Fire fighting alarm in Gardner/Snyder Thermal Power Station is centralized at S-1 & S-2 central control room, however, almost all the alarm are defective.

2) Malaya Thermal Power Plant

Fig. 5E-22 MULTI-POINTS ALARM

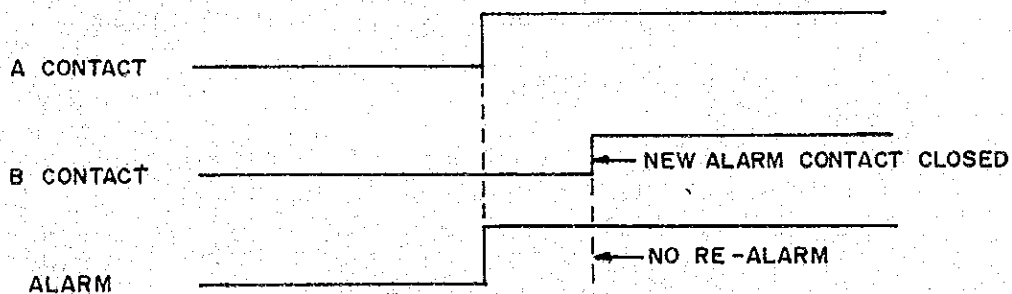
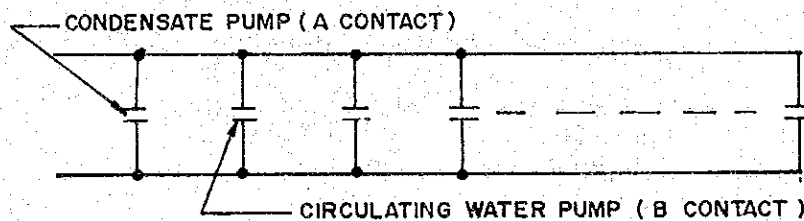
Present alarm system for multi-points is unadequate because the system does not re-alarm repeatedly when another alarm contact is closed.

In this alarm system, operators can not acknowledge new trouble at all.

Re-alarm system should be applied to alarm having parallel contacts to let operators acknowledge new trouble occurrence immediately.

Fig. 5E-23 CENTRAL CONTROL ROOM PANELS

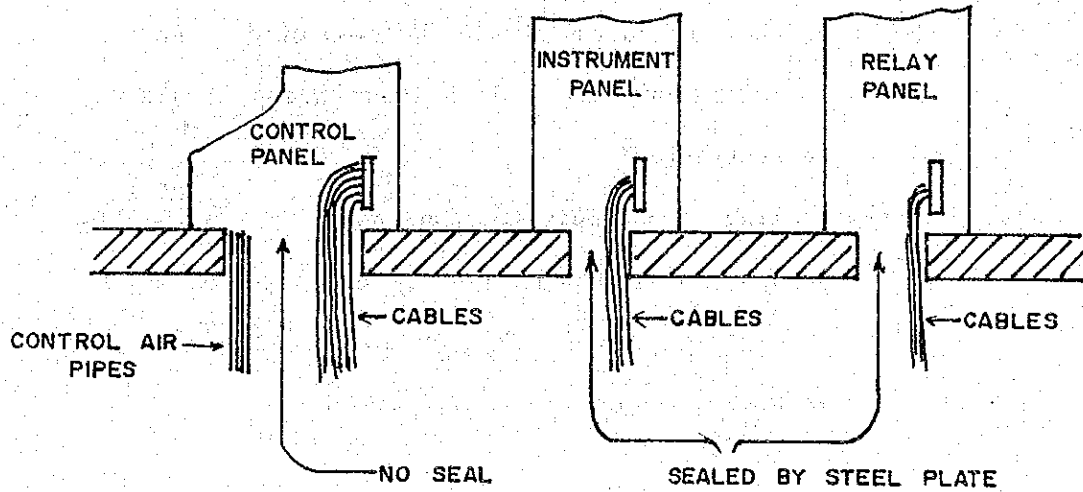
However, there still exists important problem. It is urgently required to prevent hot gas and dust, having bad influence upon the health of operators and instrument devices, and entering into the room.

To improve the central control room for S-1 and S-2 units in same condition as that of G-1 and G-2 units, following measures are recommended:

Fig. 5E-24 SEALING PLAN OF CABLE HOLE IN
S-1, S-2 CONTROL ROOM

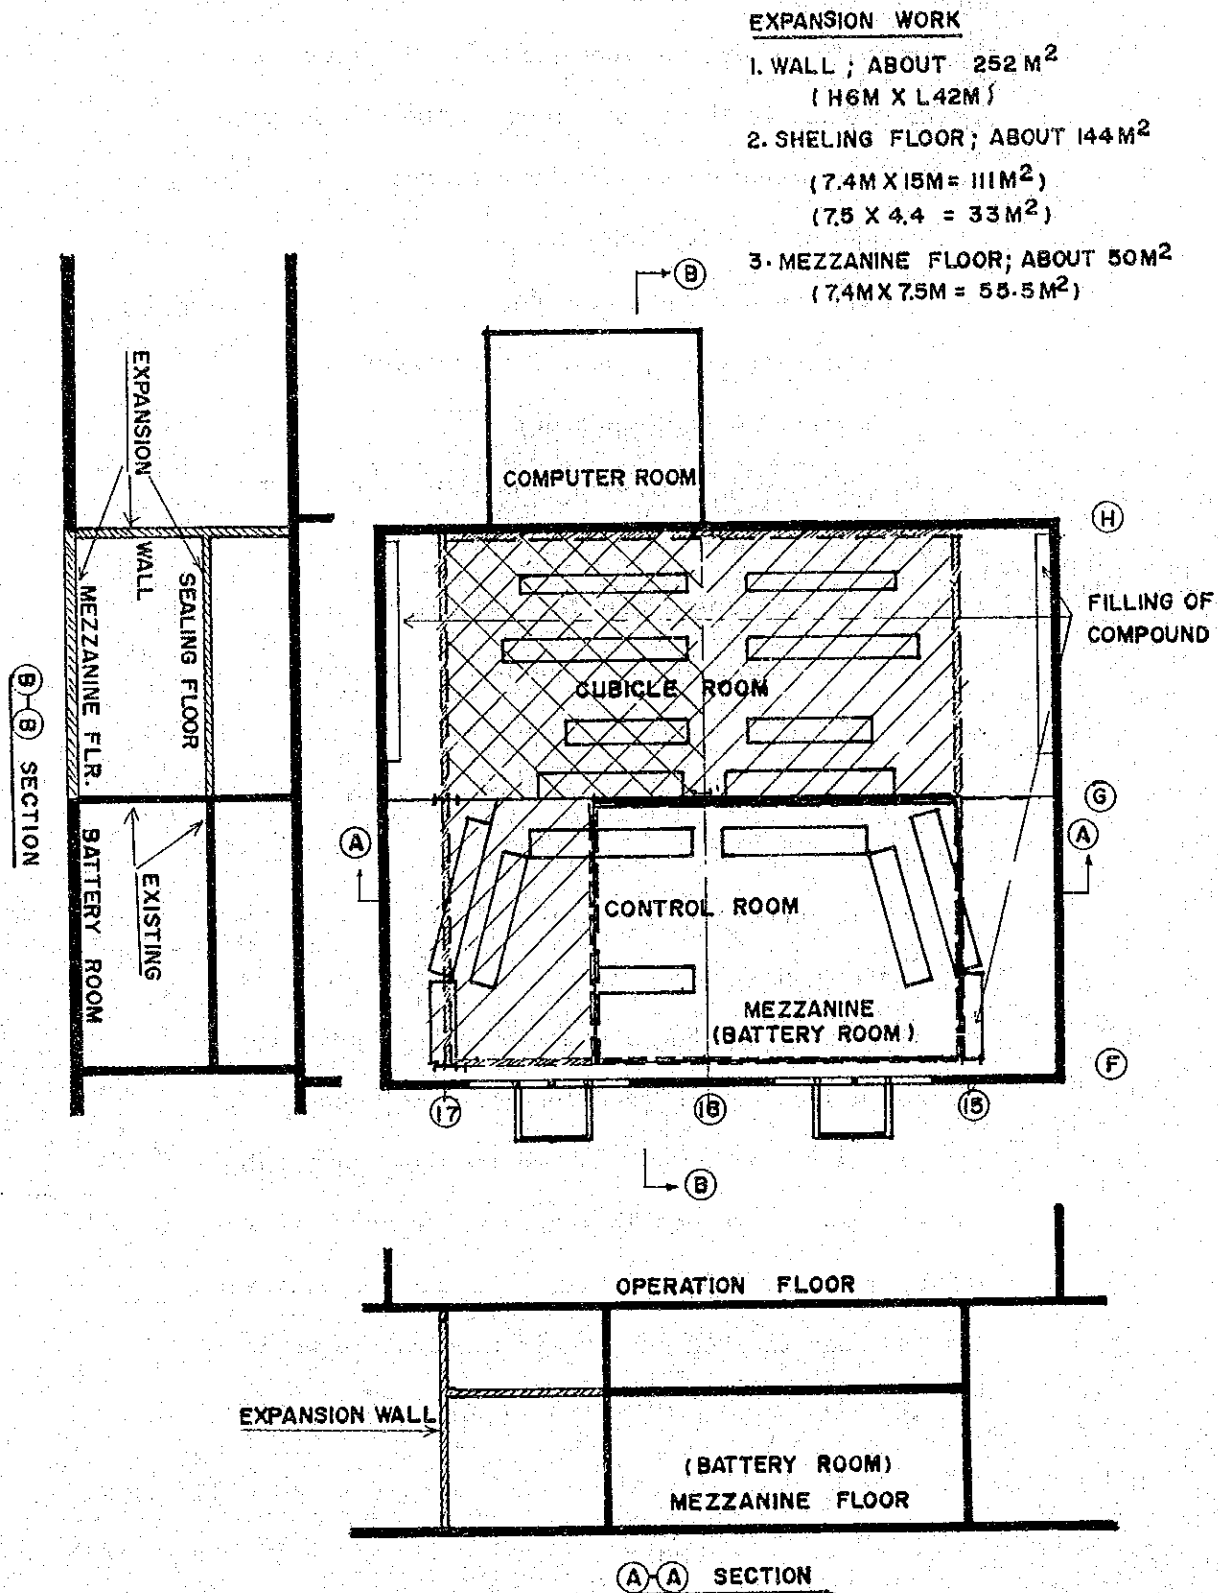
Sealing of openings only by steel plate is incomplete, and so the gap should be filled up with a compound easily treated.

Fig. 5E-25 EMERGENCY POWER SUPPLY SYSTEM

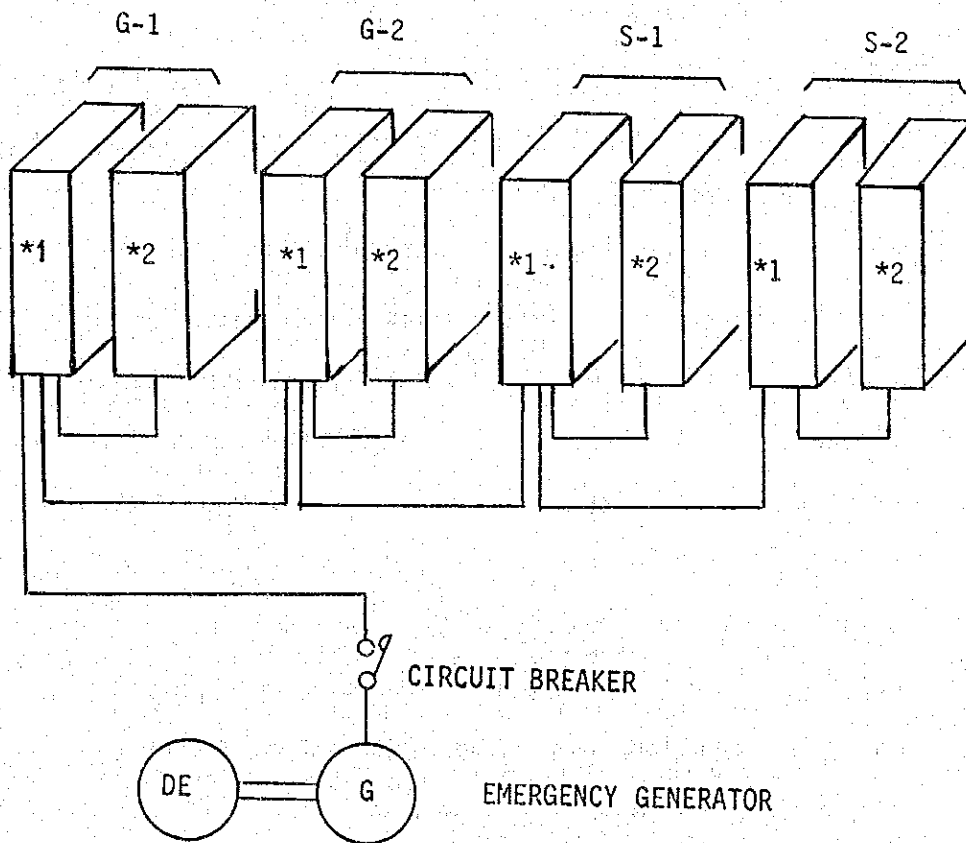
However, the power cables to each auxiliary equipment are not completed.

In the event of emergency like black-out of power plant, when the auxiliary power source transferred to emergency transformer successfully, there arises no problem. But taking unsuccessful automatic bus transfer into consideration, emergency control center units should be additionally installed near the existing control centers and stable auxiliary power should be supplied from the unit to each equipment for the purpose of safe plant shutdown. Refer to the following sketch.

*1 shows additional emergency control centers

Fig. 5E-26 STATION BATTERY SYSTEM

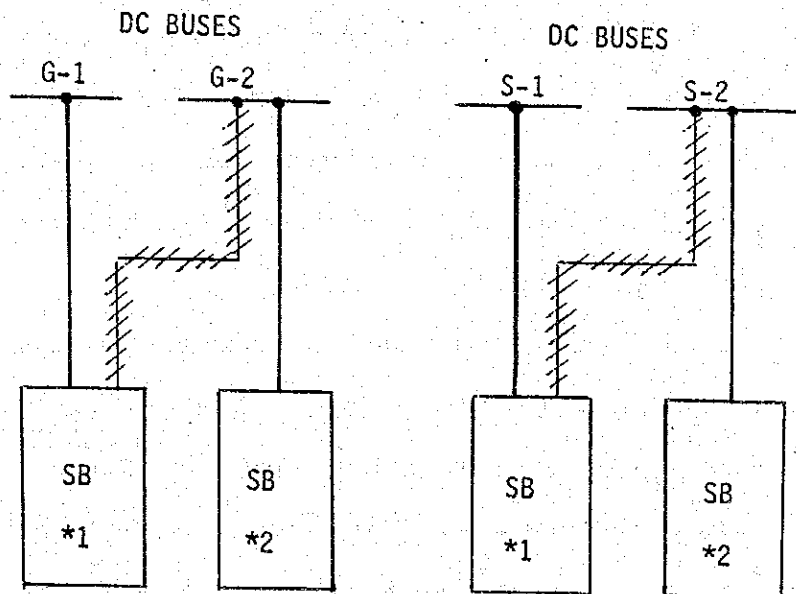
In addition to the above, station battery system should be unitized for each generating unit as follows:

NOTE: SB stands for Station Battery.
*1 and *2 show the existing batteries and additional batteries respectively.

Fig. 5E-27 CABLE MARK

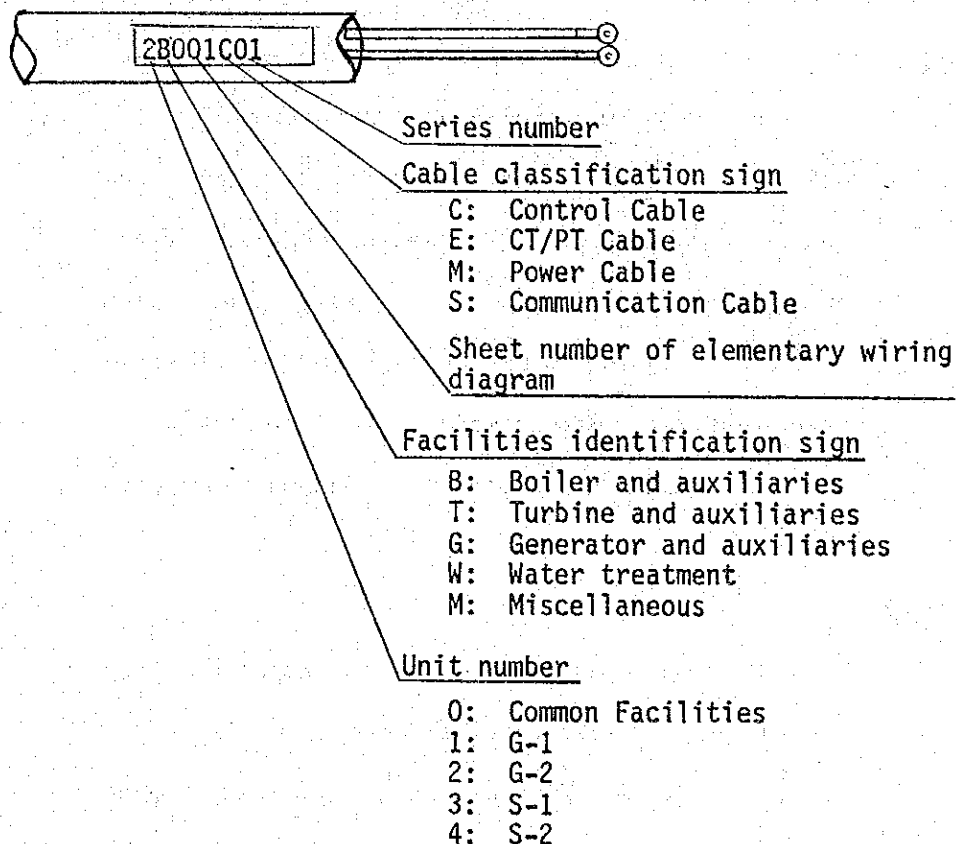
All cables and wiring incoming and outgoing to panels should be identified by cable marks and wiring marks for easy cable check.

Fig. 5E-28 EXAMPLE OF TRIPPING TIME COOPERATION

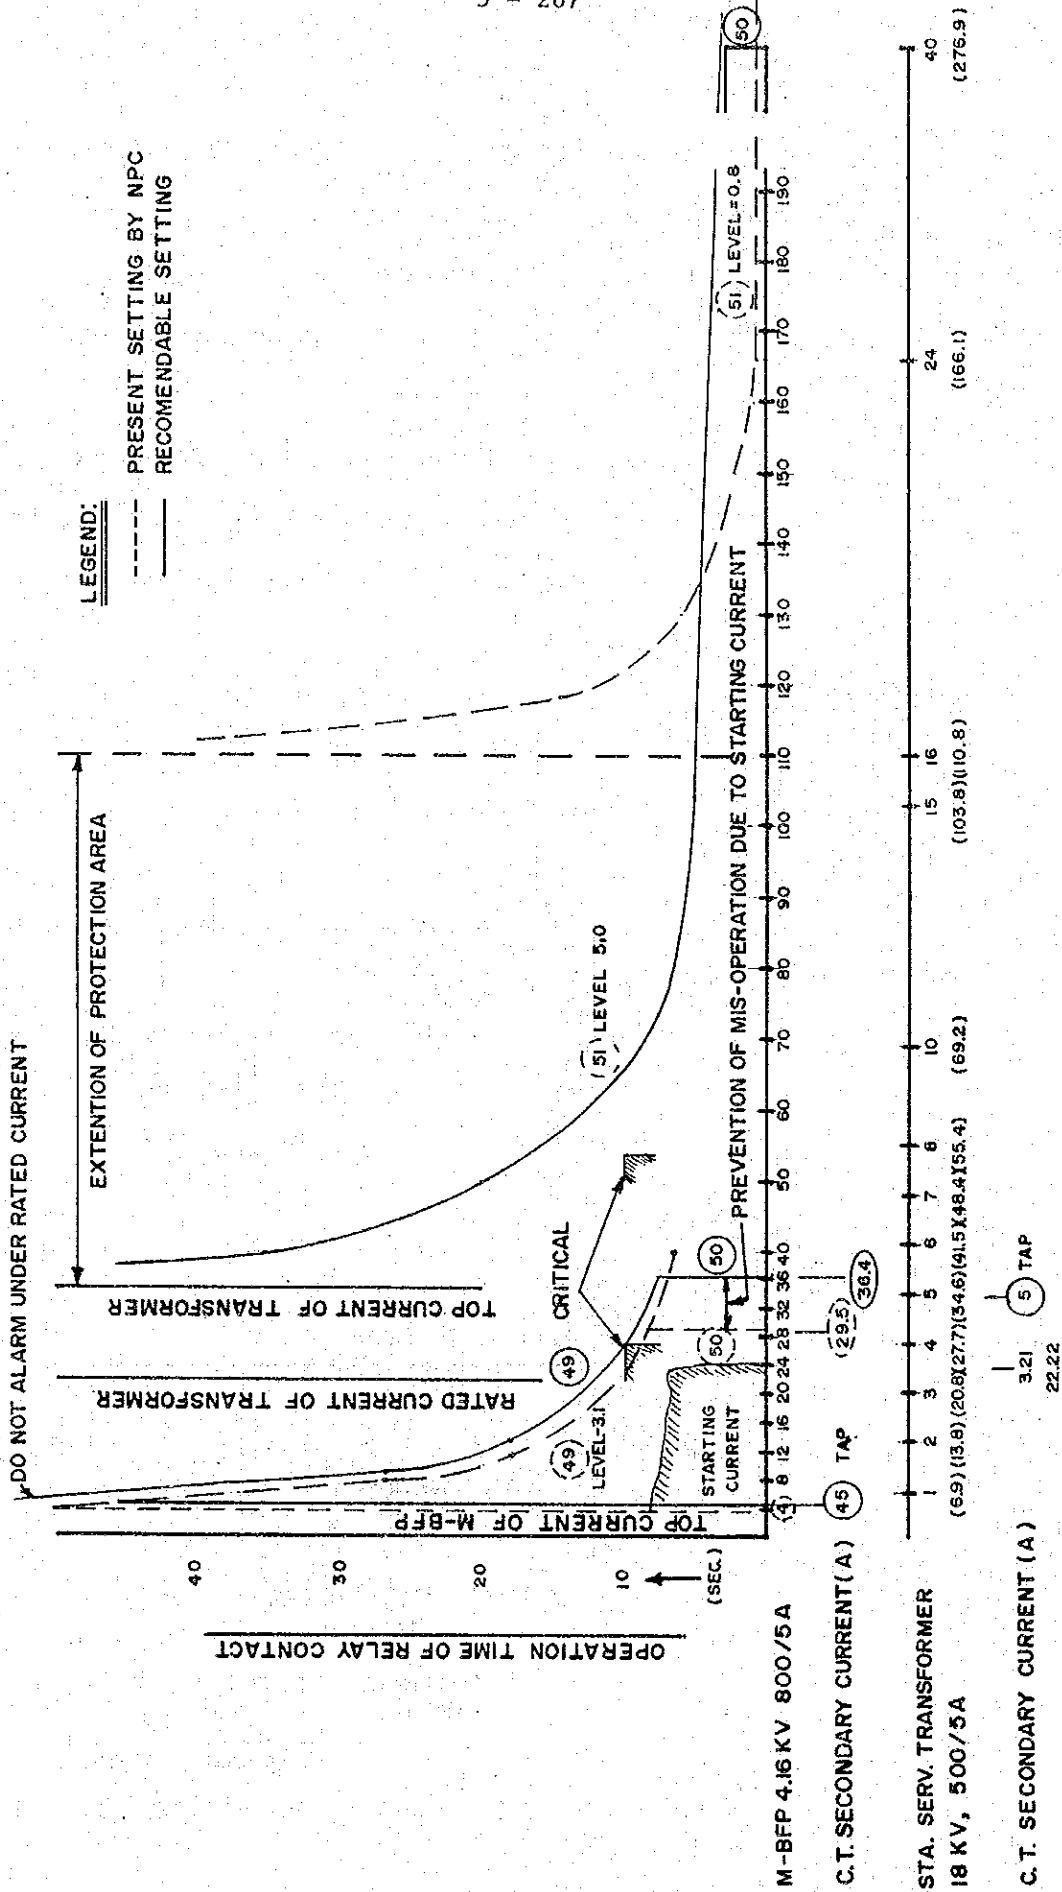
Tap of "51" element should be selected at approximately 1.5 times of the rated current, and lever should be selected so that the "51" element does not malfunction at starting rush current of motor-driven boiler feed water pump which has maximum capacity among 4.16 KV auxiliary motors.

For an example, setting of OCR should be decided in accordance with the following result of calculation.

Fig. 5E-29 PT SECONDARY CIRCUIT CONNECTION

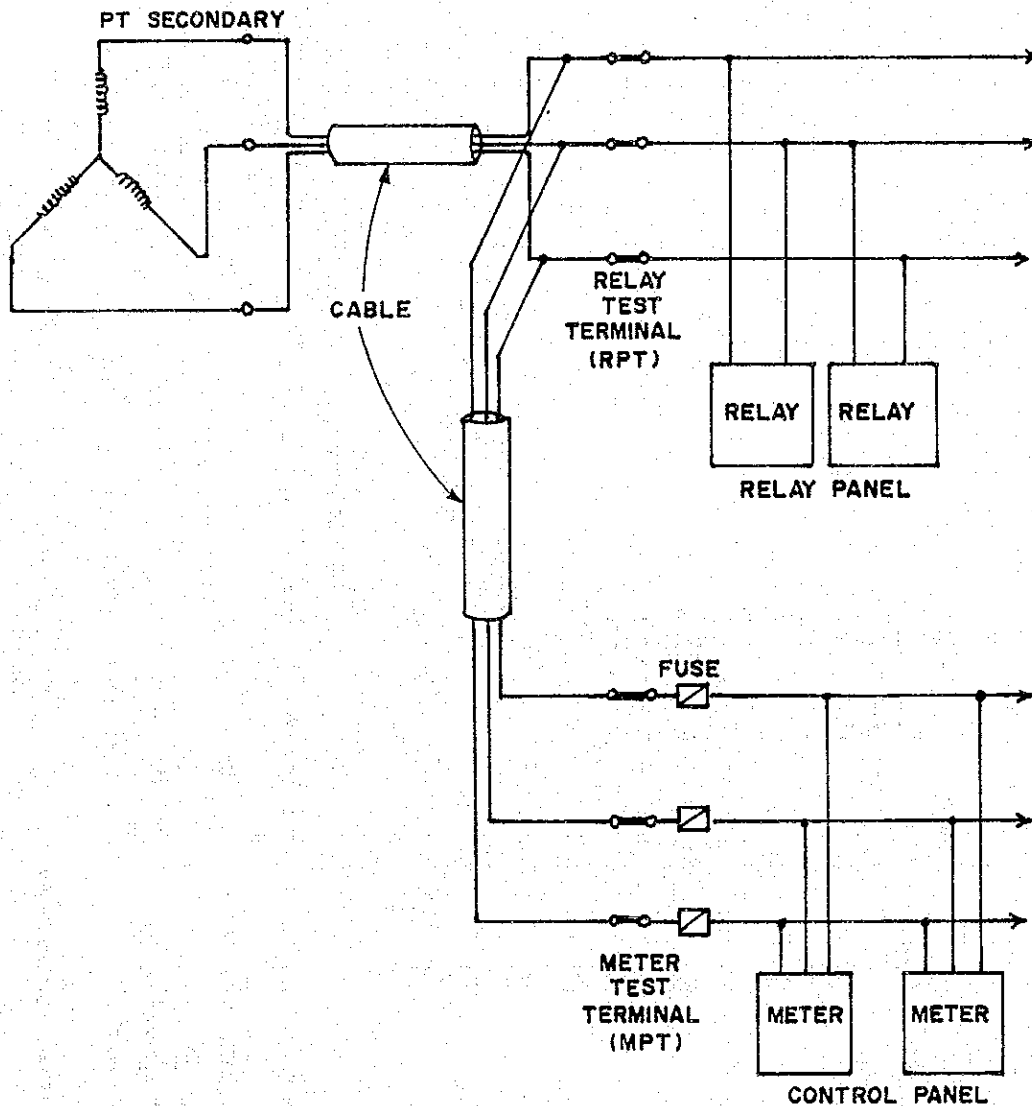
In the existing PT secondary connection only one circuit for protective relays and metering instrument is commonly used. Connection of PT secondary for protective relays and metering is recommendable to be divided into two circuits as follows:

- * Inspection, repair and re-adjustment of meters can be carried out only by removal of MPT keeping protective relays placed into service under normal operation.
- * In the event of short circuit accident in metering circuit, malfunction of protection relays such as under voltage relays and distance relays can be avoided.

Fig. 5E-30 CT SECONDARY CIRCUIT CONNECTION

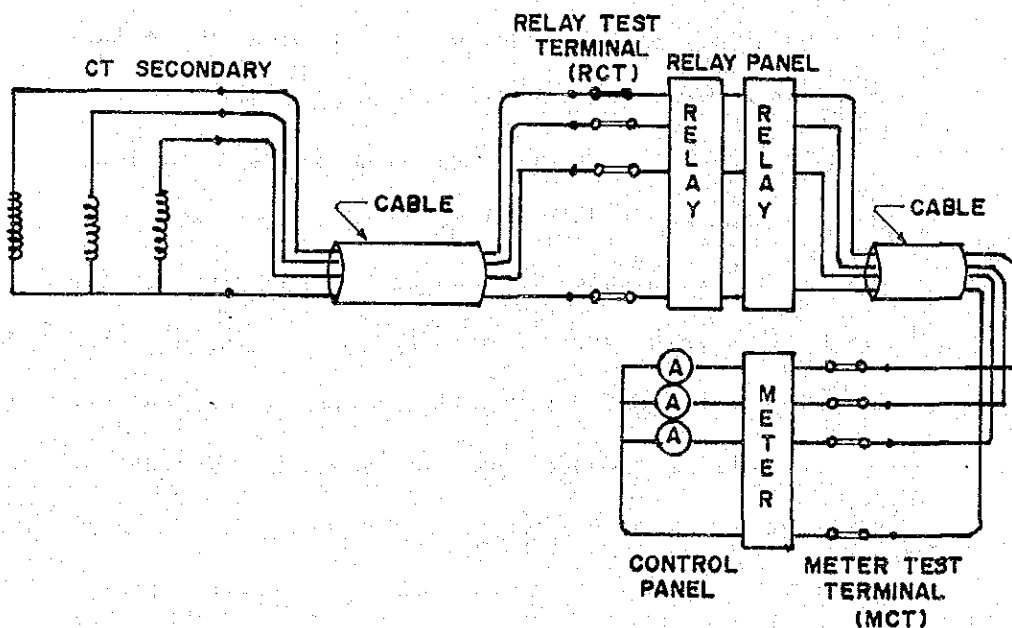
It is in principle desirable to install two CTs for meters and protection relays, respectively. However, in case of one CT, following circuit should be considered for easy maintenance and safe plant operation.

- * Inspection, repair and readjustment of meters can be carried out only by short-circuit of MCT keeping protection relays placed into service under normal operation.
- * In the event of short-circuit accident in metering circuit, malfunction of protection relays (differential percentage relays) can be avoided.
